**PARK CITY PLANNING COMMISSION MEETING
SUMMIT COUNTY, UTAH
February 17, 2021**

Planning Commission Staff Report

Subject: Park City Mountain Base Area Development
Project #: PL-20-04475
Authors: Alexandra Ananth – Senior Planner
John Robertson – City Engineer
Julia Collins – Senior Transportation Planner
AECOM – Transportation Consultant to the City
Date: February 17, 2021
Type of Item: Administrative Public Hearing – Substantive MPD Modification

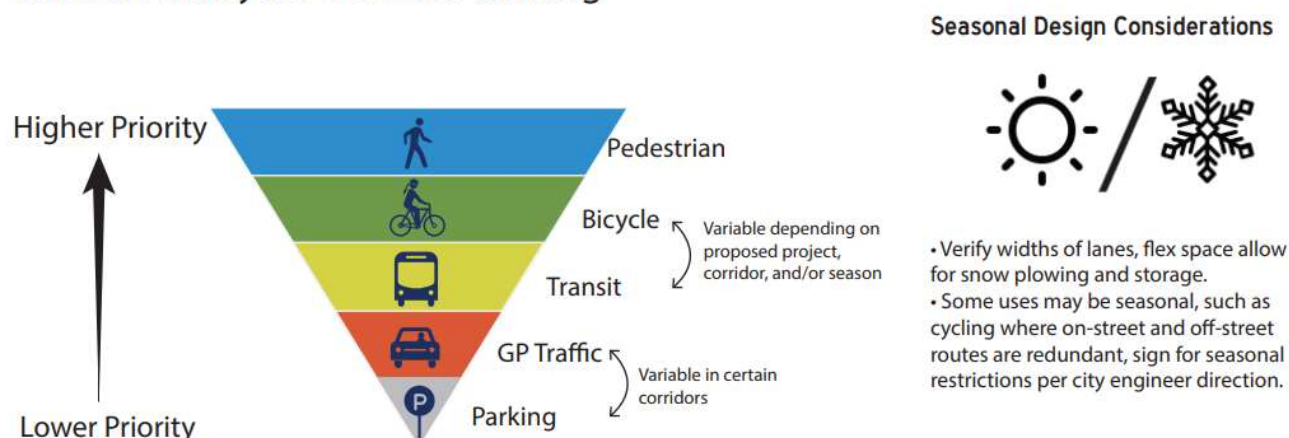
The congestion on Empire Avenue, particularly in the PM peak, impedes access for adjacent residents. Although these congestion problems exist under current conditions, the City's General Plan, Resort Center Area Plan Principle 6, is to decrease destination resort impacts on surrounding residential communities. Table 1 of the February 3, 2021 Hales Engineering memo shows that with a 20% global reduction in anticipated traffic volumes (assuming current mode split), most intersections will operate at an acceptable LOS. This criteria will not be met unless the development plan includes concrete measures to reduce vehicular access to the site.

In addition, the plan did not include specific measures to discourage resort traffic on Three Kings Drive.

Pedestrian Access & Safety: Three Kings Drive

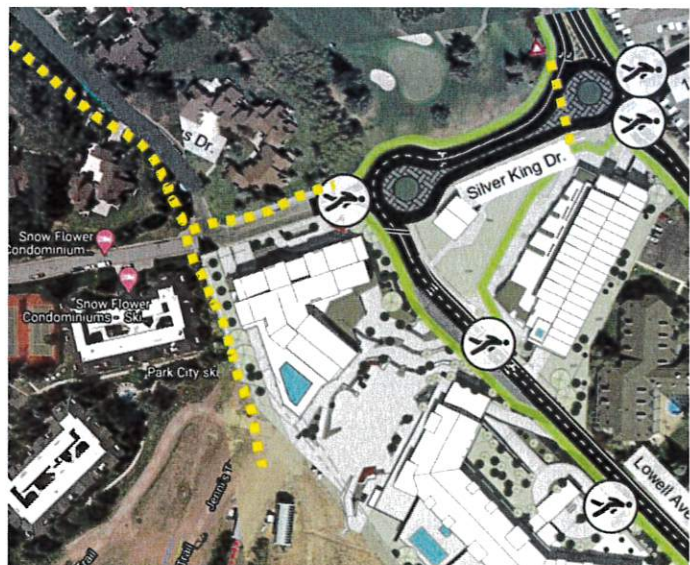
- Three Kings Drive has in recent seasons become a perilous pedestrian-vs-auto scenario. There is no paved/plowed walkway, so wintertime pedestrians must walk in the driving lanes, often trapped into traffic by roadside plow-banks.
- Likewise, bus stops are rarely cleared, so transit dumps bus riders out onto slippery snowbanks a few feet from moving cars. Ever-increasing auto traffic – comprised of local residents, visitors searching a back door to the resort, Uber/Lyft drivers avoiding 224, and city busses – zooms by snowbank-trapped pedestrians on these sloped, often-slick roads.
- To make the matter worse on high-use days, busses often delay, so skiers waiting for a ride between Silver Star and PCMR eventually give up and choose instead to walk in traffic.
- Please see Three Kings traffic flow concerns above.

- Please add a paved-and-plowed pedestrian walkway between Parcel E and Silver Star – ideally, set back from the road. This is not PCMR property, but there is a wide setback between the road and any existing development, plenty of space for a universally beneficial walkway.
